ADDENDUM NO. 2

RE: **River Hill High School – Hot Water Reheat Coils (HCPSS Bid #079.23.B3)**

SECTION 5
M-1.18
SCALE: 1/8"=1'-0"

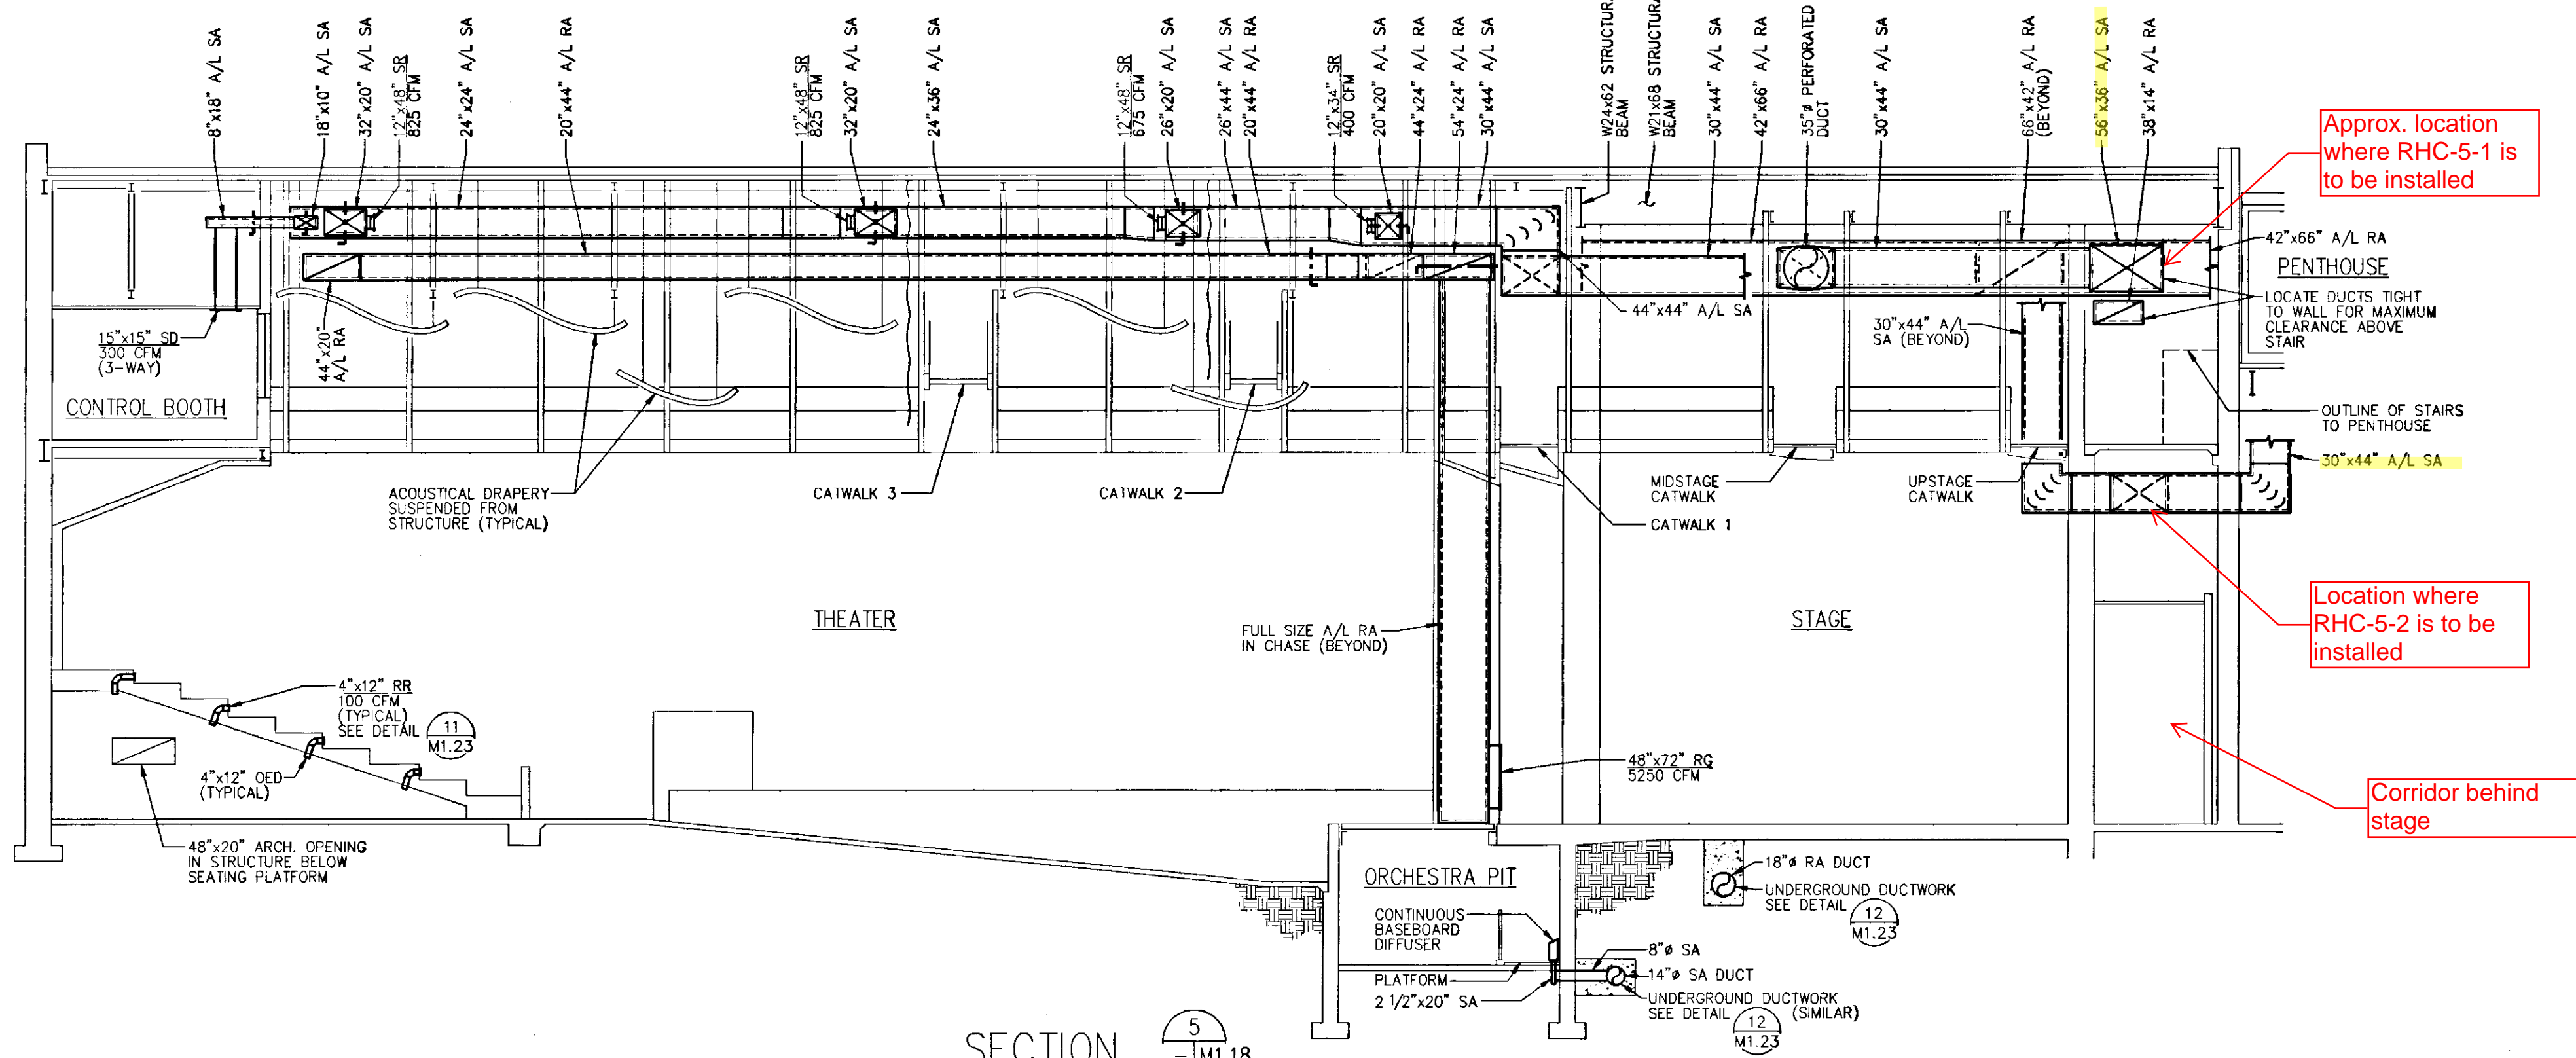
- a. No. Provide piping and joints as specified in section 232113.
4. **For RHC-5-2, will there be enough room to slide the coil into the ductwork with the adjacent wall?**

- a. No. Both reheat coils will be larger than the existing ductwork that it is to be installed due to the requirement of a maximum air pressure drop of 0.10" water column at maximum airflow, as indicated in the Schedule on Drawing M-2. Therefore, reheat coils will require flange connections and transitions between reheat coils and existing ductwork, as indicated on Drawing M-1.

- b. Attached is section 5 / M1.18 from the original building drawings for reference.
5. **Sheet Note 7 indicates to relocate existing light fixture. Where is the light fixture to be relocated to?**
